THE THANET EXTENSION OFFSHORE WIND FARM ORDER

Written Representations submitted on behalf of the Port of London Authority

| Document Ref. | PLA 3 |
| Date | 15 January 2019 |

Sea Zones Plan – Reduction in red line boundary

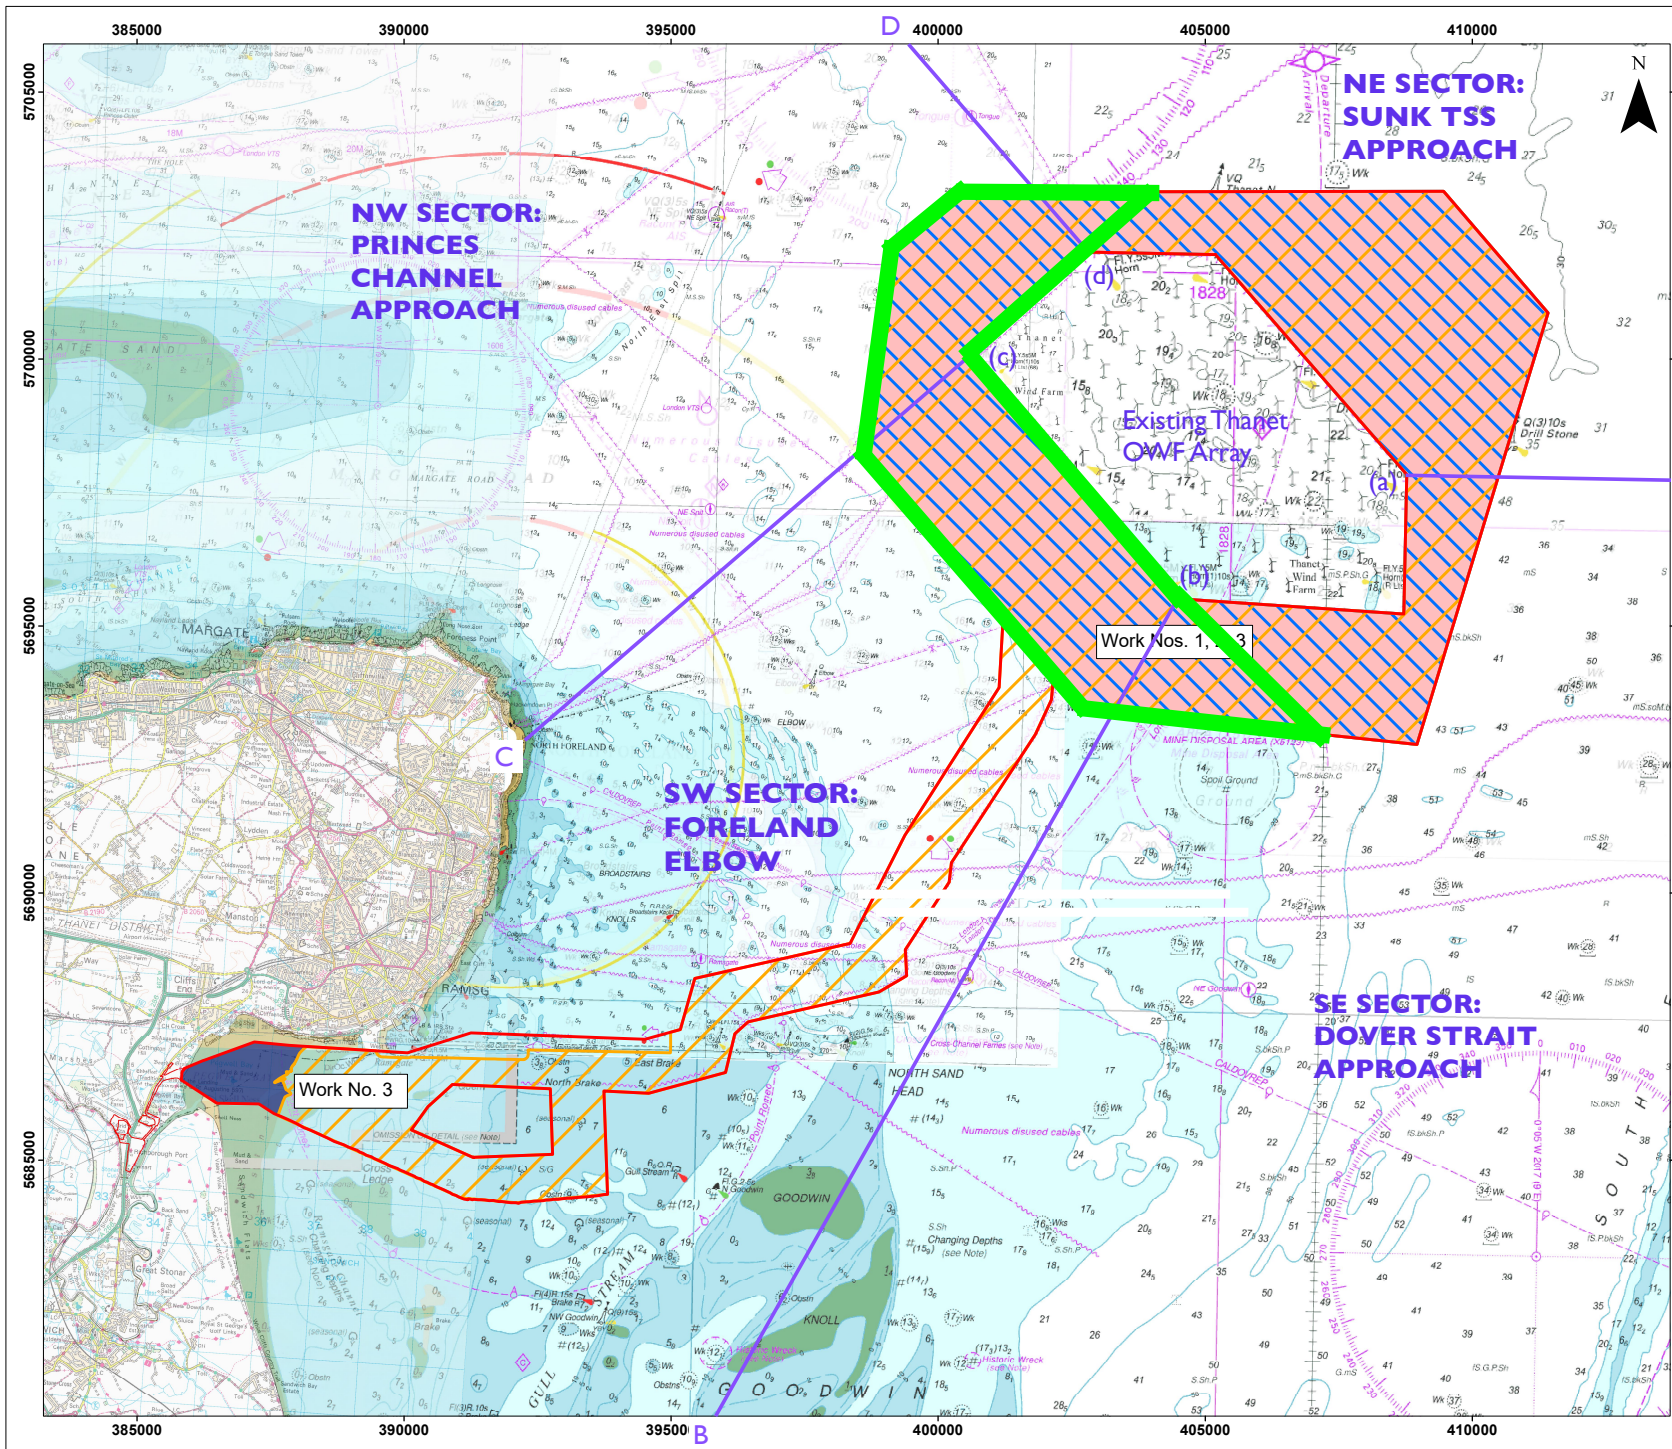
7.1 The mitigation desired by the PLA is a further reduction in the Red Line Boundary of the application at the Western boundary of the site. Although the Applicant has already proposed a reduction in the Red Line Boundary, it is the position of the PLA that this is insufficient to address its concerns about navigational safety. The PLA's desired revised Red Line Boundary is illustrated on the Sea Zones plan included with these Written Representations as Appendix 1. This plan illustrates the area of the proposed extension which the PLA requests be removed from the DCO edged in green. Reducing the area of the proposed red line boundary to this extent would address the PLA's concerns with the Scheme.

Proposed area for reduction shown edged green.
